DRAFT REPORT

3rd meeting of GRRF Informal Working Group on Automatically Commanded Steering Function

Venue: AUDI Training Center – Airport Munich, Germany.
 Chairman: Mr. Christian Theis (D) and Mr. Hidenobu Kubota (J)
 Secretariat: Mr. Jochen Schaefer (CLEPA)
 Dates: 02.-03. September 2015
 Website: <https://www2.unece.org/wiki/display/trans/ACSF+3rd+session>

6.2.2.15. Annex 7**6.2.2.16. FU1 (lane keeping test)**

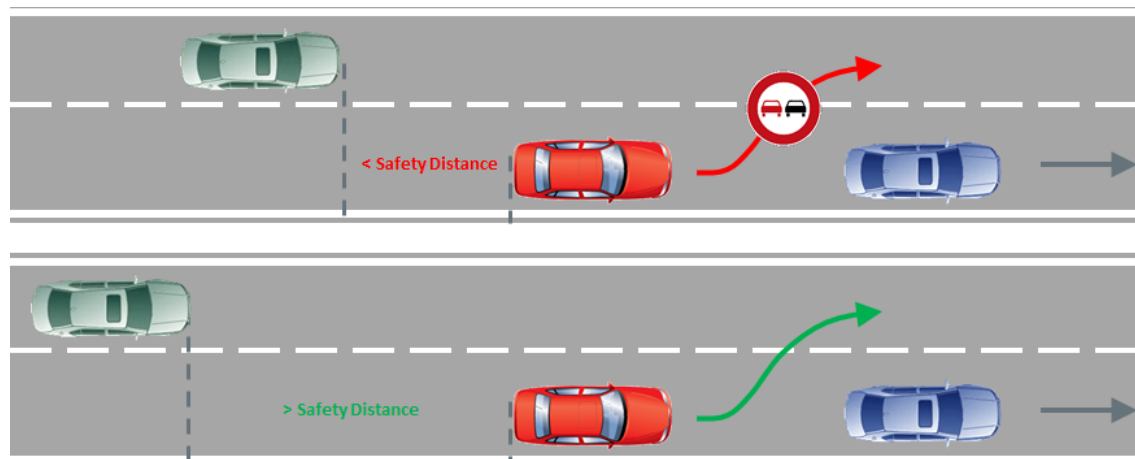
UK: system should also work without lead vehicle

D: main reason was to cover also Traffic Jam Assist (TJA) which may need a lead vehicle

EC: maybe different systems need different tests

UK: propose to concentrate first on CAT E

D: for CAT E no lead vehicle should be necessary

OICA: There may be CAT E systems only up to 40 km/h for traffic jam

D: In a traffic jam with max. 40 km/h a lane change makes no sense

Debate, whether the blue vehicle shall accelerate or change the lane, without result

Homework: OICA to define a new proposal for FU1-Test (CAT E)

6.2.2.17. FU 2 (new Lane change test)

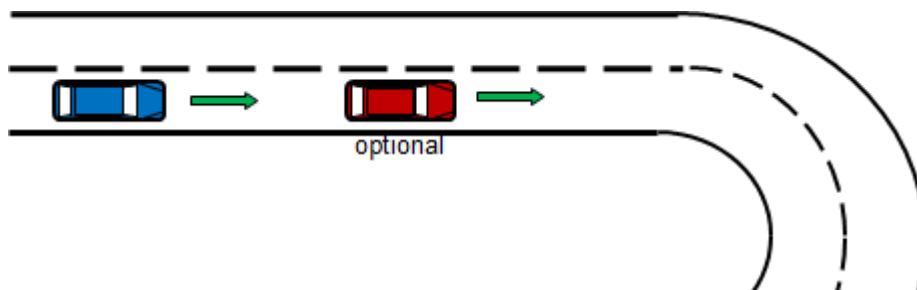
The current FU2-Test ([ACSF-03-09](#)) is very difficult to verify on a test track

CLEPA: proposes new Lane change test ([ACSF-03-14](#))

CPs confirm, that the test is in principle ok

Missing: - pass/fail criteria
- define safety distance requirements

Homework: CLEPA to complete the missing points

6.2.2.18. FU 2 (Lane change test with obscured vehicle)

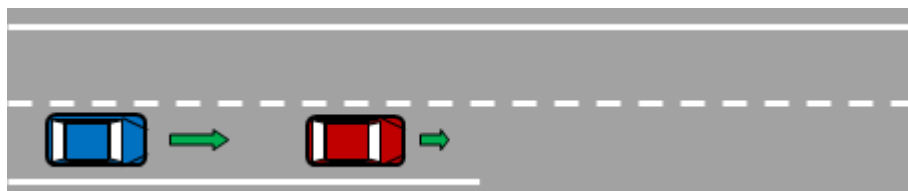
UK: a test, maybe by simulation, would be necessary to test the system, if a fast vehicle is coming from behind

CLEPA: explained document ACSF-03-05 where the physical parameters/values can be calculated. Even the sensor position, vehicle width etc. could be modified if sheet is unprotected by the password (“test”)

UK: the test should ensure that the vehicle can detect a narrow target approaching from behind before commencing a lane change manoeuvre

Homework: OICA/CLEPA to propose a test

6.2.2.19. TR 1 (tight curve: ay beyond system boundaries)

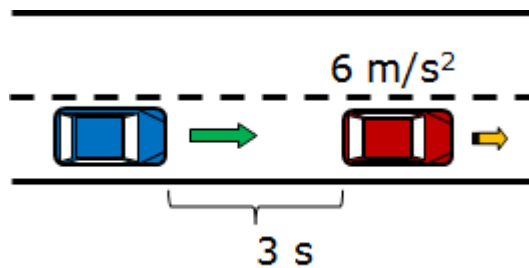
CLEPA: as a CAT E system should only work on motorways, it might be difficult for the technical Service to find an appropriate test track

OICA: sees no problem to run the test also on a “normal” test track

Homework: D + OICA + CLEPA to rework the test for CAT E only

6.2.2.20. TR 2 new (missing lane marking)

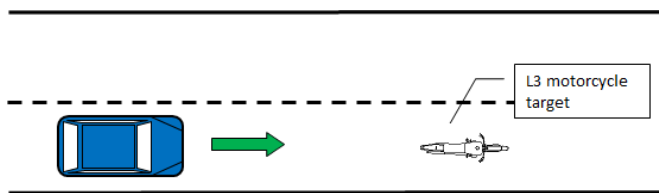
NL: propose that the driver will get the transition demand 5s prior the lane marking ends

OICA: with the current technic this is not possible

CPs confirm, that the test is in principle ok

Homework: D to rework the test
